Subject: Dayco Corporation/L. E. Carpenter Superfund Site
USEPA ID No. NJD002168748
Response to Agency Comments on the Additional Wetland Delineation
Sampling Results

Attachment 1
Responses to EPA and NJDEP Comments on
Additional Wetland Delineation Sampling Results
Dayco/LE Carpenter Corporation Superfund Site, Wharton, NJ

DRAWN BY: DGS	SCALE: AS INDICATED	PROJ. NO. 212321.0000.03
CHECKED BY: JD	DATE PRINTED:	FILE NO. 212321.0000.03.07-08.dwg
APPROVED BY: JD		<b>FIGURE 8</b>
DATE: FEBRUARY 2014

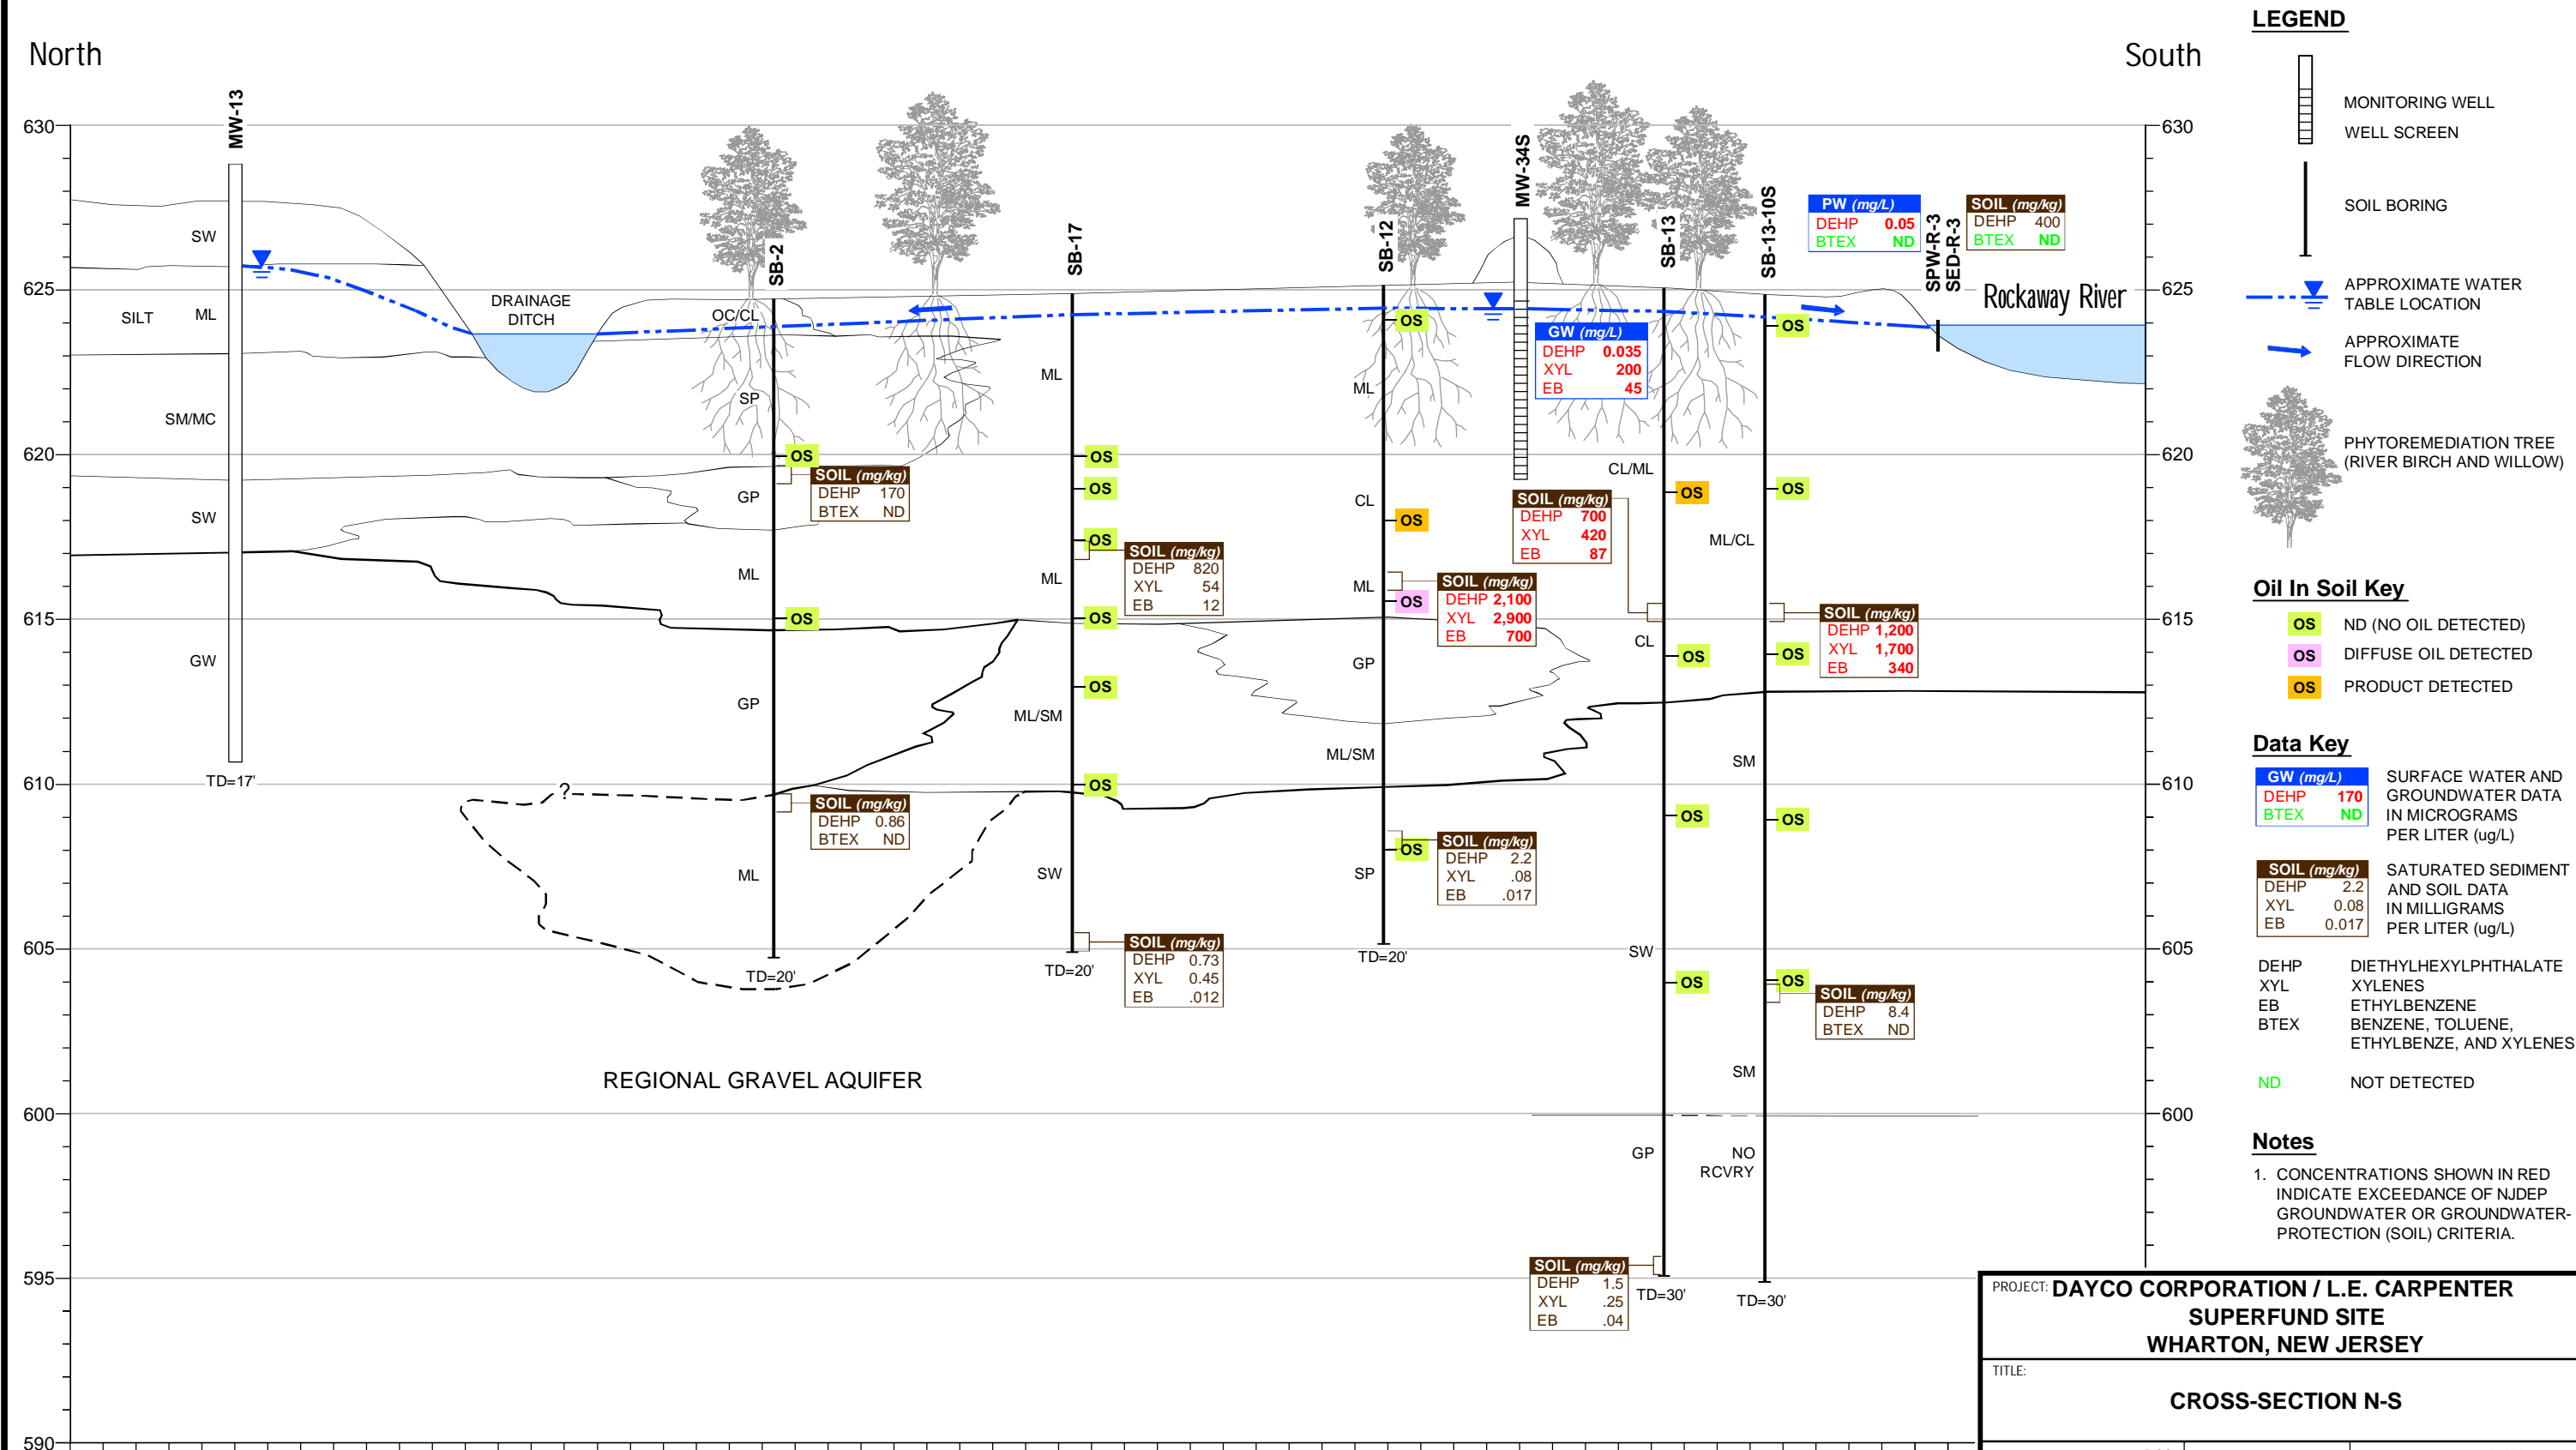
- 3. Continuous borehole profile sampling of both soil and groundwater is needed to fully and accurately delineate the both the lateral and vertical extent of the contaminants.***

4. ***Samples must be collected at sufficient depth at each location to clearly demonstrate the bottom elevation of the impacted area(s). Targeted depths for all boring and sampling should be a minimum of 30 feet bgs.***

8. ***Figure 1, submitted as part of Progress Report No. 39 is not an adequate representation of the area or sampling results. The work plan should include confirmation that the sampling results will be reported in cross sectional and surface view maps that are of sufficient scale and detail for focus on the area of concern. The scale used in Figure 1 was insufficient.***

is a west-east cross section through the area and Figure 8 is a north-south cross section. Figure 9 is a schematic drawing that portrays a conceptual regional and site specific model of groundwater flow. The strong upward vertical gradients that exist within the Site as shown on the conceptual model diagram are supported by on-site head data from existing and historical well clusters.

The attached cross sections confirm that the 20-30 foot depths of the MW-30 Supplemental RI soil borings, coupled with historical data, are sufficient to establish vertical extent. Lower constituent concentrations observed in saturated soil samples may be due in part to drag-down phenomena during sampling. No significant contamination is expected to occur at deeper levels based upon data from other on-site well clusters. Namely, historical data from the previously abandoned MW-14 cluster located within the wetland area, as shown on the attached figures, and existing well clusters MW-28 and MW-30 reinforce the absence of impacts at deeper levels. The 2005 source reduction confirmed the shallow occurrence of the former product and product smear zone for the original primary source area.

The Figures presented in Attachment 2 have been prepared at a scale (1 inch equals 40 feet) that better focuses on the wetland area. As previously discussed, the requested cross-sections are included as Figures 7 and 8.
